## **LEIGHTON PLACE SUBDIVISION**

The purpose of this application is to create a 41-lot subdivision from two metes and bounds parcels.

APPLICATION NUMBER 14 DATE June 17, 2004  
APPLICANT Leighton Place Subdivision  
REQUEST Subdivision

## DETAIL SITE PLAN

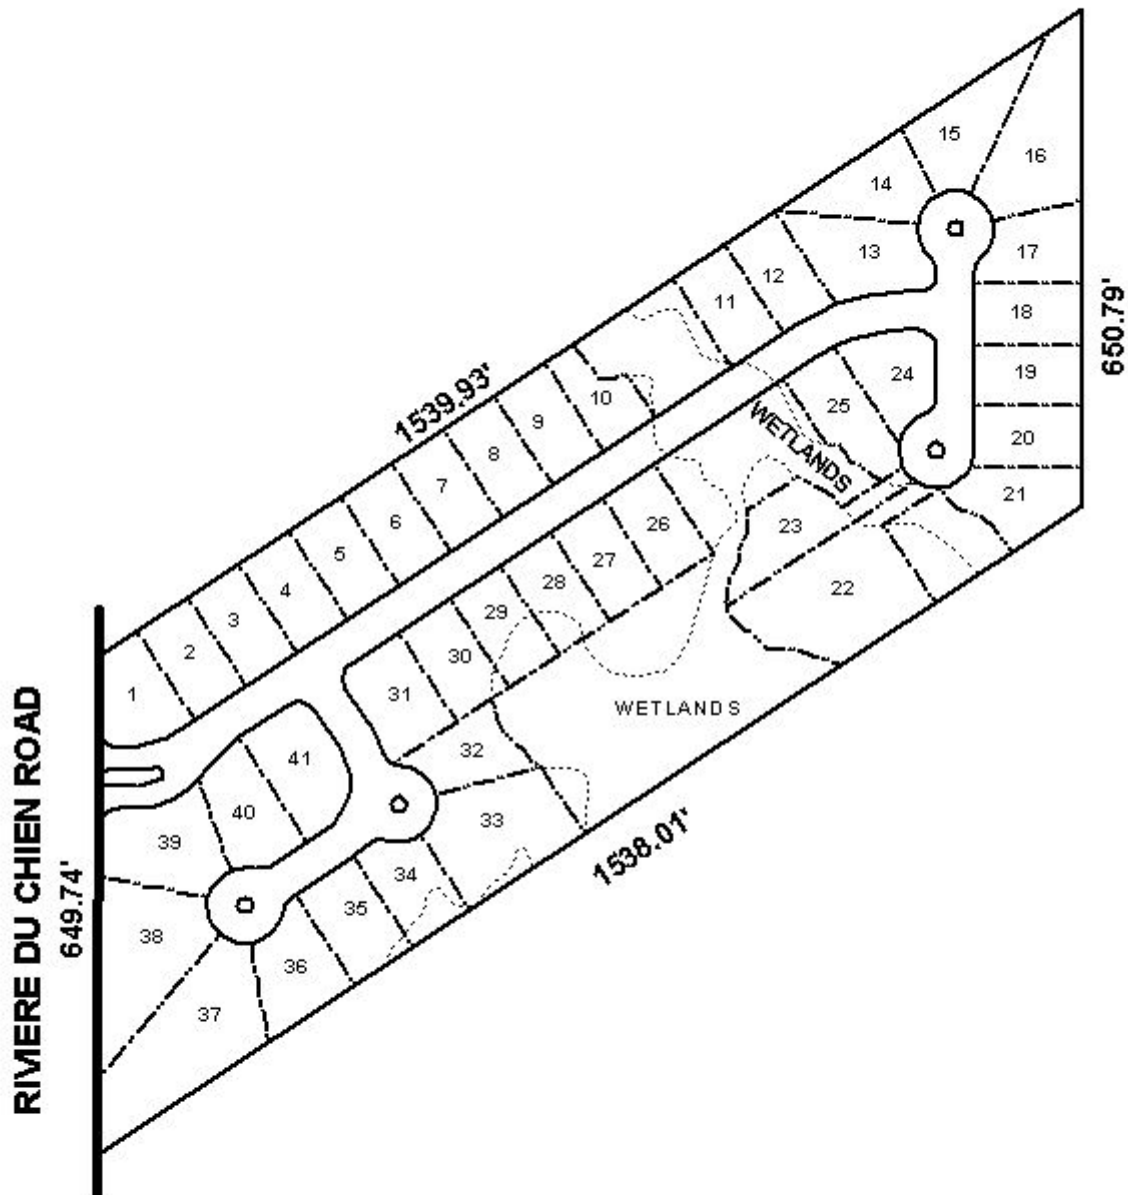
Numerous lots are located on corners and several as proposed would be considered double-frontage lots. Therefore, these lots should be limited to one curb cut to the new subdivision streets; specifically, Lots 1, and 37 thru 39 should be denied access to Riviere du Chien, and Lots 13, 24, 31 and 41 should be limited to one curb cut. Additionally, as proposed Lots 22 and 23 are illustrated having 25' road frontage, which is not typical of the development. Waivers of Sections V.D.2., minimum dimensions of at least 60-feet wide at the building setback line, and V.D.3., maximum width to depth ratio would be required, but not recommended.

As illustrated on the preliminary plat there is an area of land that are not labeled as common areas and should be labeled as such; these areas are located between Lots 10 and 11, Lots 21 and 22, and within the right-of-way of the new street along Riviere du Chien. These areas should be indicated on the final plat and a note stating that maintenance of all common areas is the responsibility of the property owners association.

As illustrated on the site plan an area designated as wetlands bisects the development; therefore, it could be considered environmentally sensitive and the approval of all applicable federal, state and local agencies would be required.

The 25-foot minimum building setback line is not shown but would be required on the final plat.

With modifications, the plat will meet the minimum requirements of the Subdivision Regulations and is recommended for Tentative Approval subject to the following conditions: 1) the placement of a note on the final stating that Lots 1 and 37 thru 39 are denied direct access to Riviere du Chien; 2) the placement of a note on the final plat stating that all corner lots are limited to one curb cut each; 3) all common areas be indicated on the final plat (including wetlands) and a note on the final plat stating that maintenance of all common areas are the responsibility of the property owners association; 4) approval of all applicable federal, state and local agencies; and 5) placement of the required 25-foot minimum building setback line on the final plat.
